Bid Bulletin #1

PROJECT: Northeast Community College
Applied Technology Building, Physical Plant Building, Sitework

DATE: July 3, 2013

PHYSICAL PLANT / APPLIED TECHNOLOGY BUILDINGS CIVIL PACKAGE NORTHEAST
COMMUNITY COLLEGE
801 East Benjamin Avenue
Norfolk, NE 68702-0469
BCDM Project No. 3527-01

SHEET C2-9, SANITARY SEWER PLAN & PROFILE STA. 330+00 TO STA. 336+00:

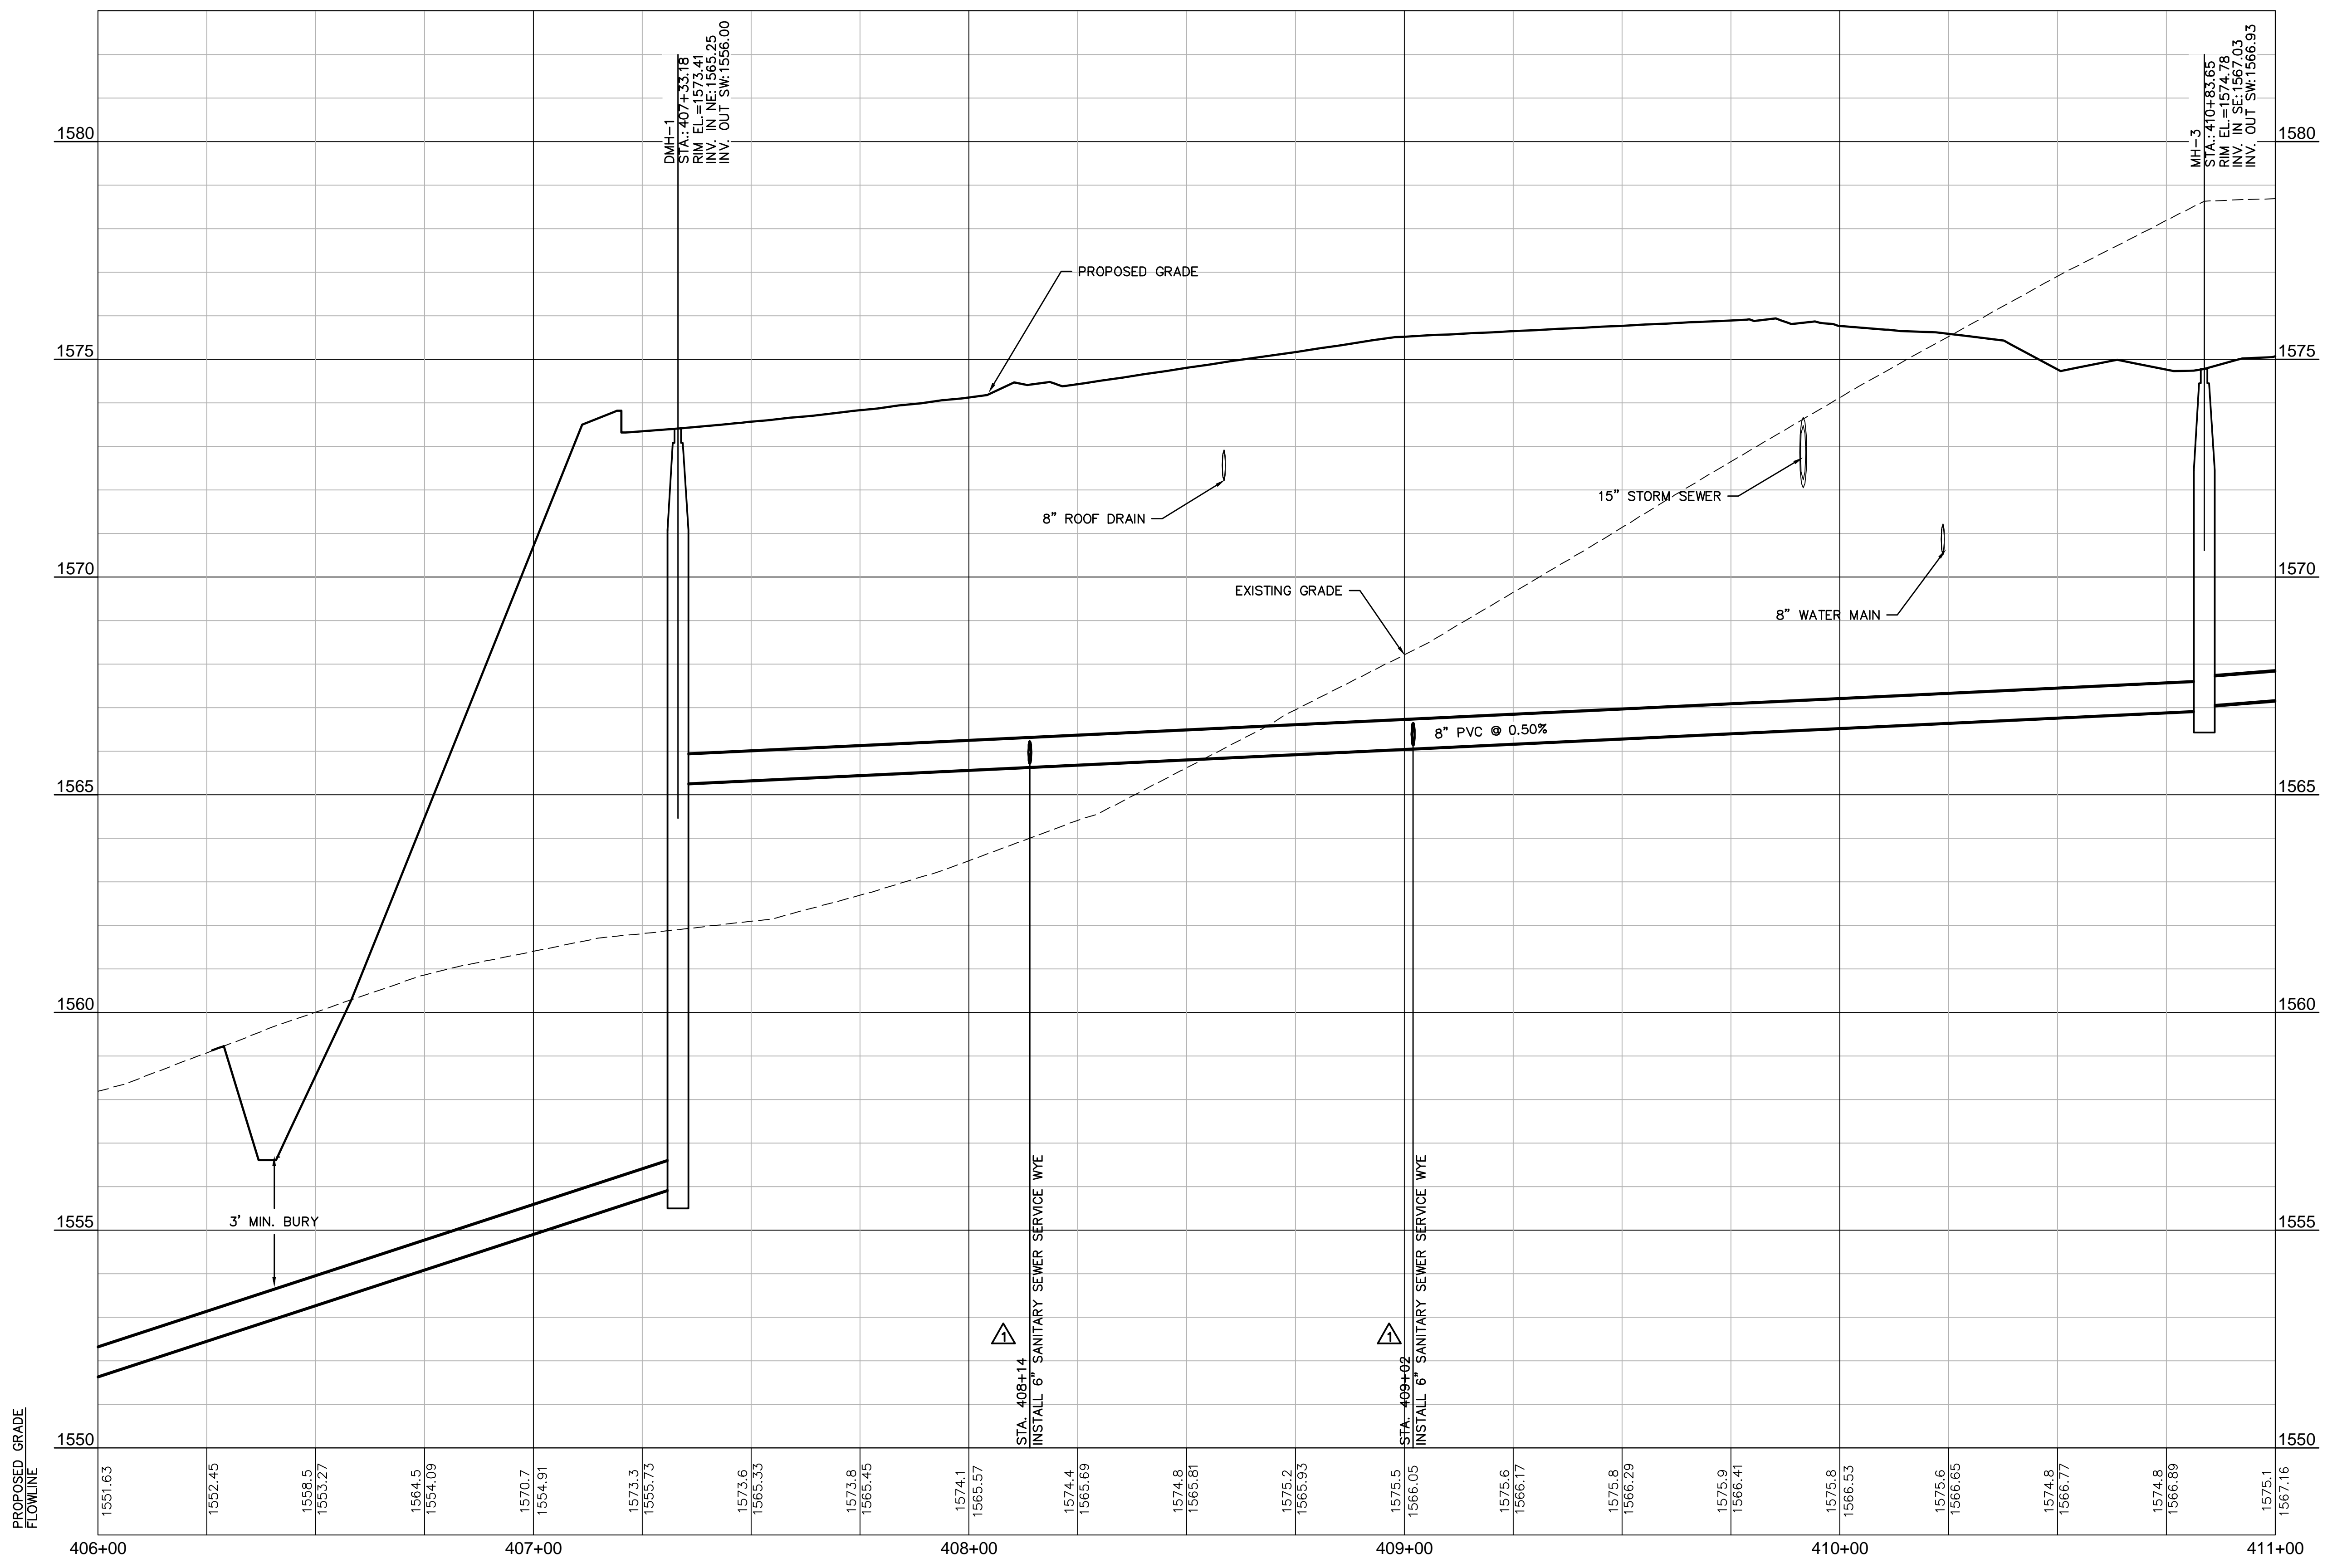
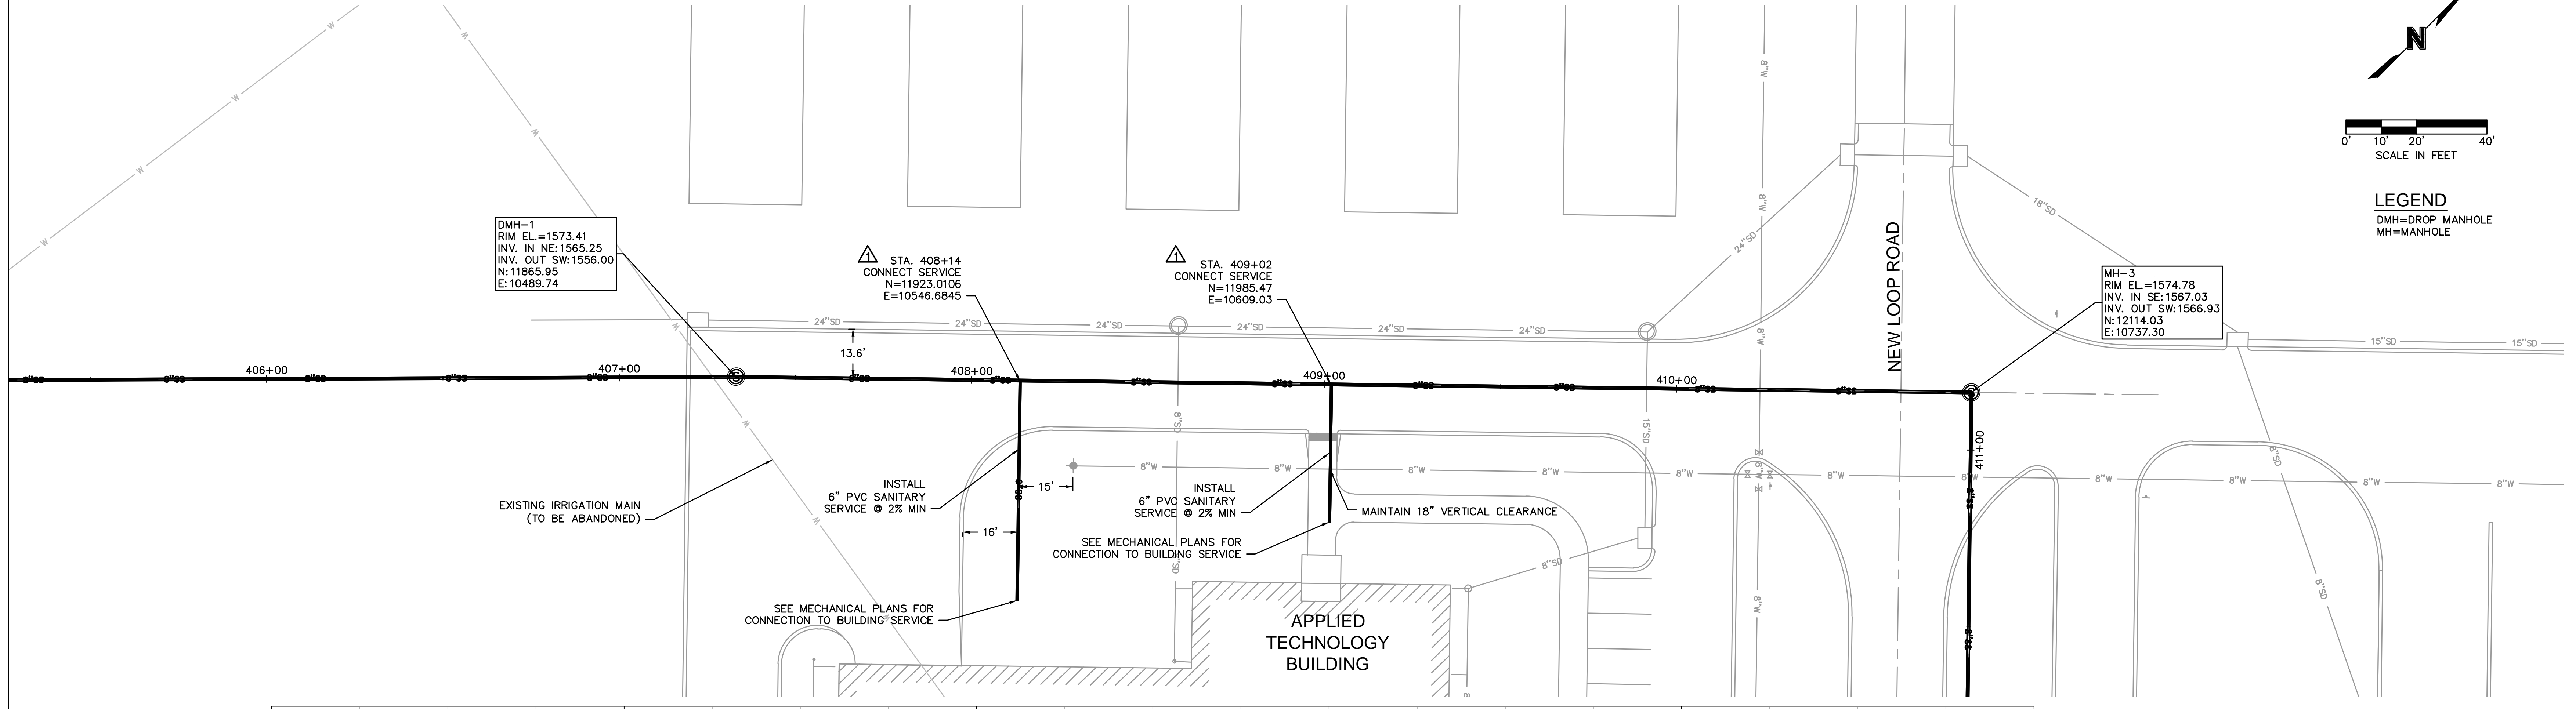
- a. Replace sheet in its entirety with the attached sheet C2-9.
- A sanitary service was added at Sta. 408+14.
 - A sanitary service was moved from Sta. 408+89 to Sta. 409+02 and slope was changed to 2.0% minimum to accommodate building connection location.

sketch **E3-1Aa**

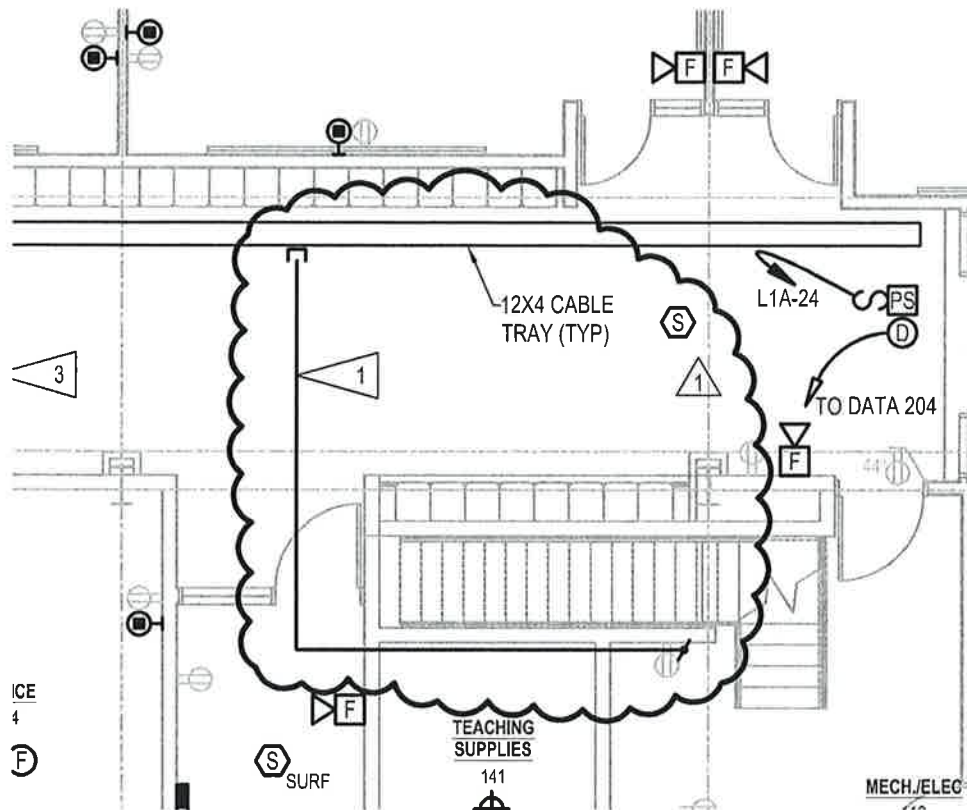
- d. See sketches E2-1Ba.
2. Sheet E3-1A Floor Plan - Electrical - Area A - Special Systems
 - a. See sketch E3-1Aa
3. Sheet E3-2B Floor Plan - Electrical - Area B - Special Systems

2 FOUNDATION PLAN - AREA 'A' ALT. AT-1
1/8" = 1'-0"

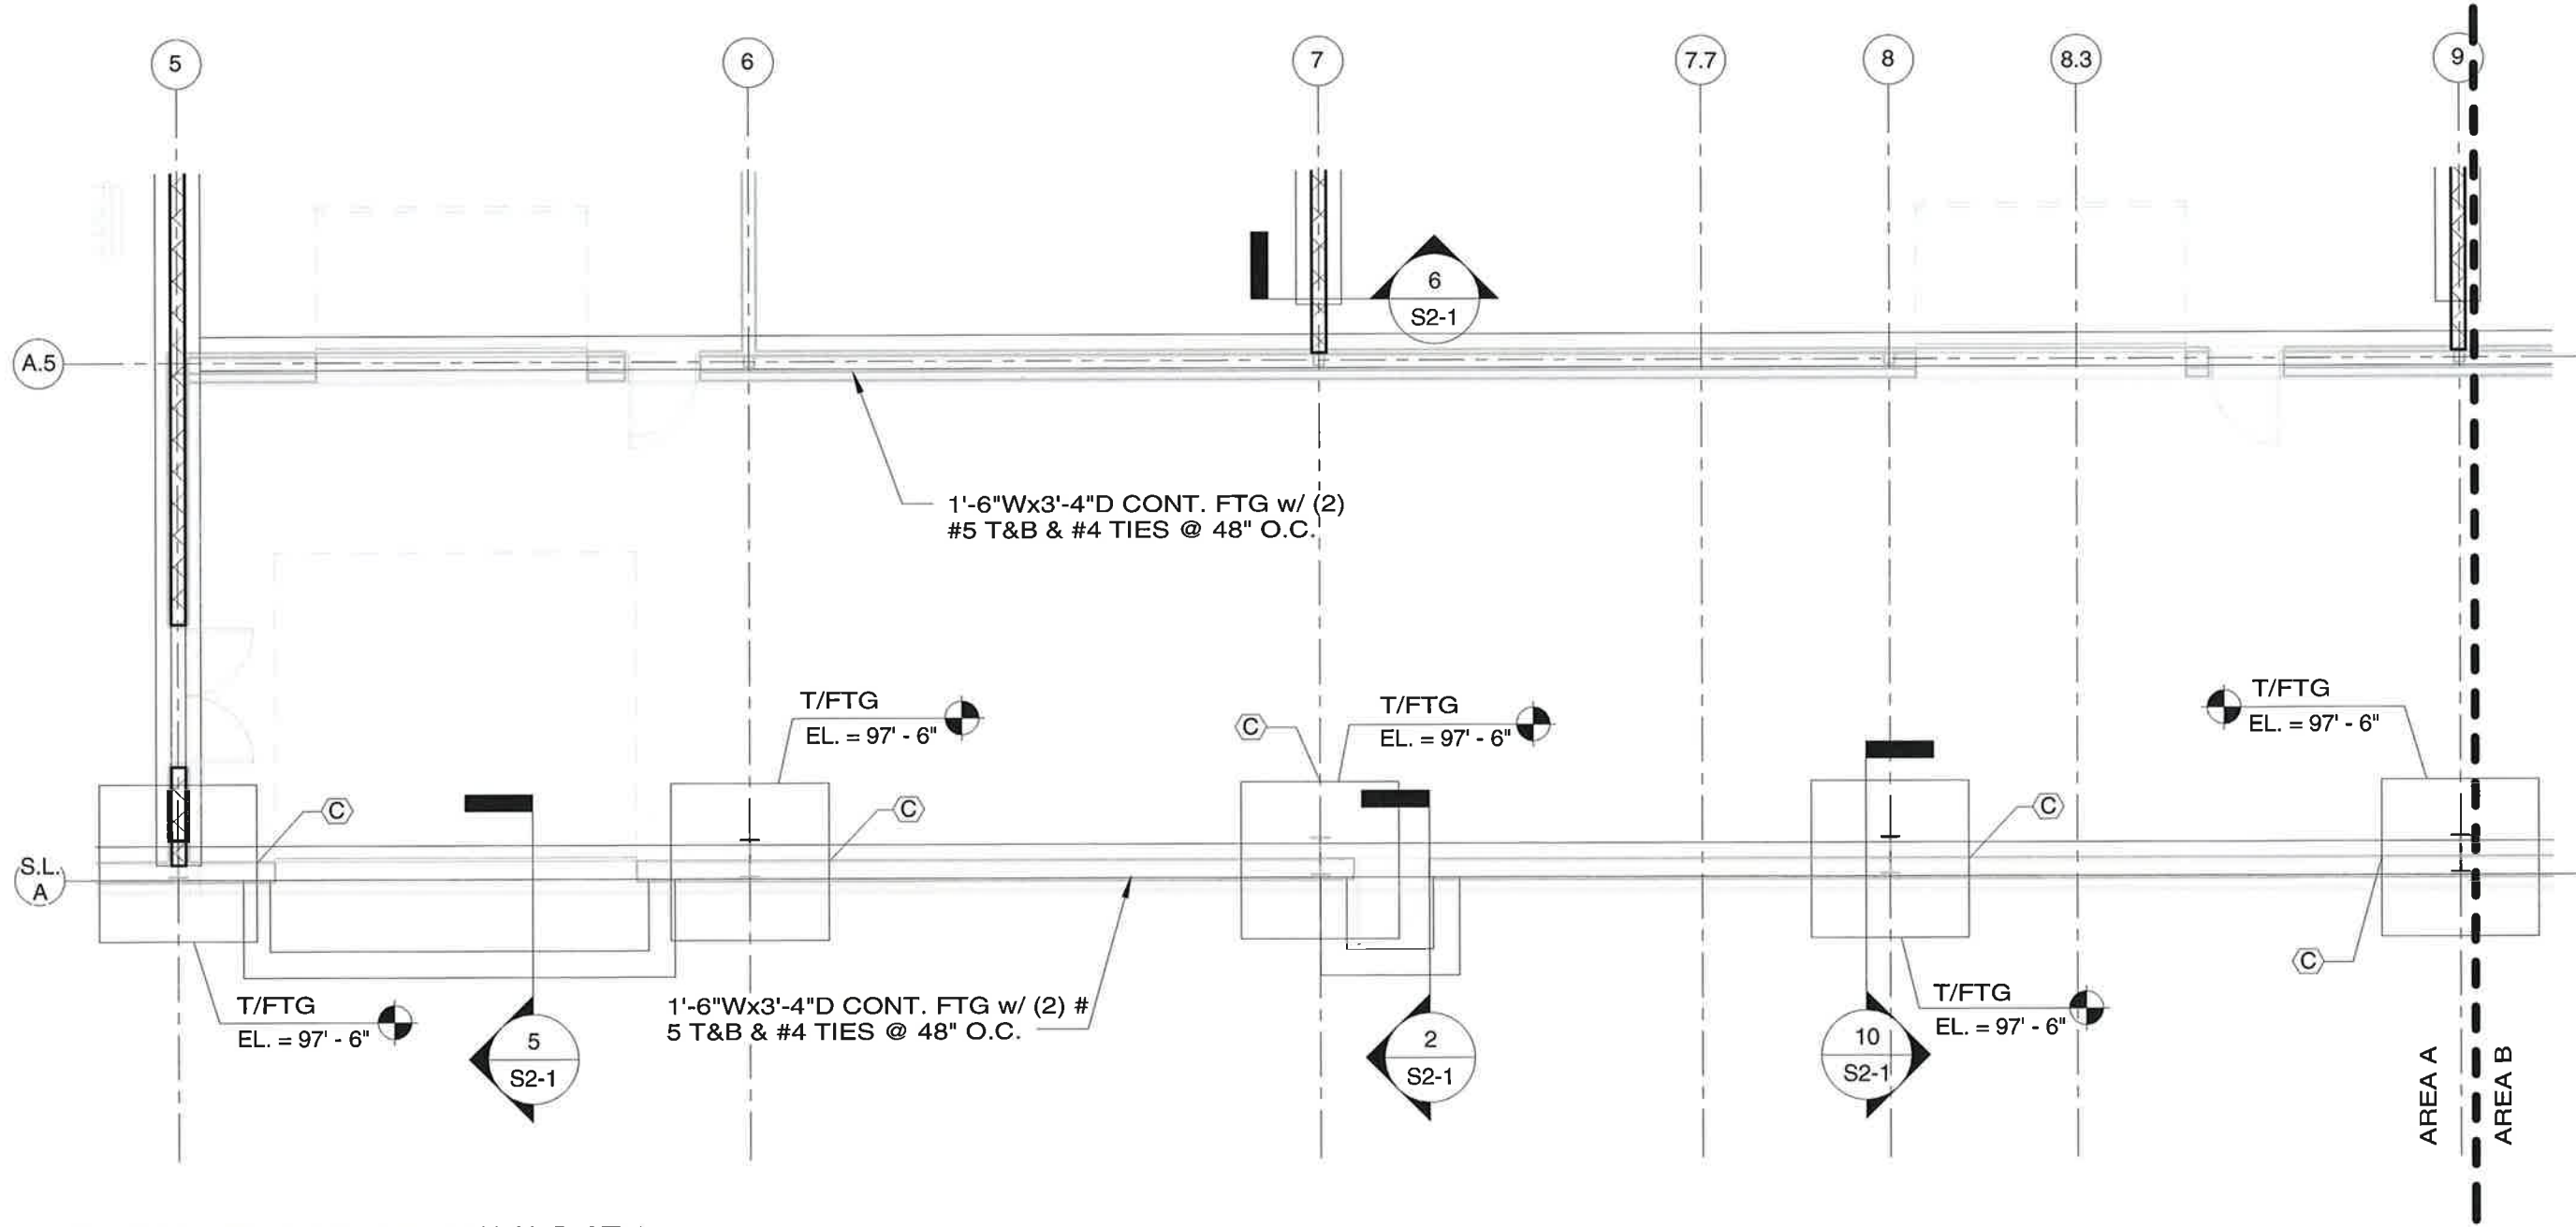
- a. Detail 1: Revise foundation plan as shown on attached partial plan SSD-3.
- b. Detail 1: Revise foundation plan as shown on attached partial plan SSD-6.
- c. Add Detail 2, PARTIAL FOUNDATION PLAN – Area 'A' Alt. AT-1, See SSD-1.
